Report on meeting of the Pause subgroup and the Consultants

30th July 2021

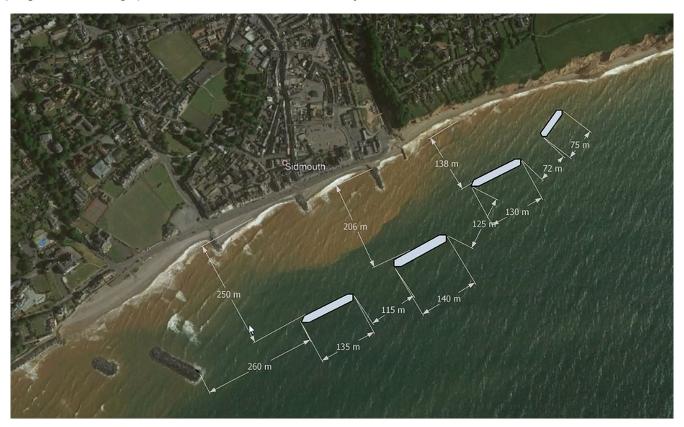
They showed the option below. Some initial calculations have been done based on this. These calculations show that directly behind the islands there will be no wave over-topping and so no need to raise the current dwarf wall on the Esplanade. The calculations as to whether there will be over-topping behind the gap between the islands has not yet been done.

It would protect Sidmouth against waves over-topping in both south east and south west storms even with the current low level of beach. This is to the 200 year level of protection, (which means that it should withstand events only expected to occur once during a 200 year period of time).

A member of the subgroup pointed out that this option had almost reversed the intention of the previous 2016 options.

In 2016 there was the intention to create and hold a large beach which, by its presence, would protect the town. Now the intention seemed to be to protect the town by stopping large waves reaching it, and the size of the beach had become irrelevant. He questioned why this shift in emphasis had happened. The suggestions which had been given the consultants in the Scope document were based on the idea of the beach providing the protection, with the rock structures keeping the beach in place and adding to the protection provided by the beach.

As the discussion proceeded it became clear that this 'Roll Royce' of options would be completely unaffordable.

The consultants explained that the offshore rock islands were so far off shore that they would not create a tombola effect and that they had major concerns about placing rock islands at oblique angles where they might not prevent over-topping in south easterly storms.

- 7) It was explained to the subgroup that the plan being shown would work technically but that the consultants preliminary costings indicated that it would £18 million just to construct the islands, and a recharge to put enough sediment into the system would bring the cost up to approximately £20 million.

The consultants were asked to do further calculations including looking at why the 4b option should be rejected when it had previously been part of the 'technically preferred' option, only rejected on cost grounds.

They were also asked to discover for sure whether an effective island option of any sort could be affordable.
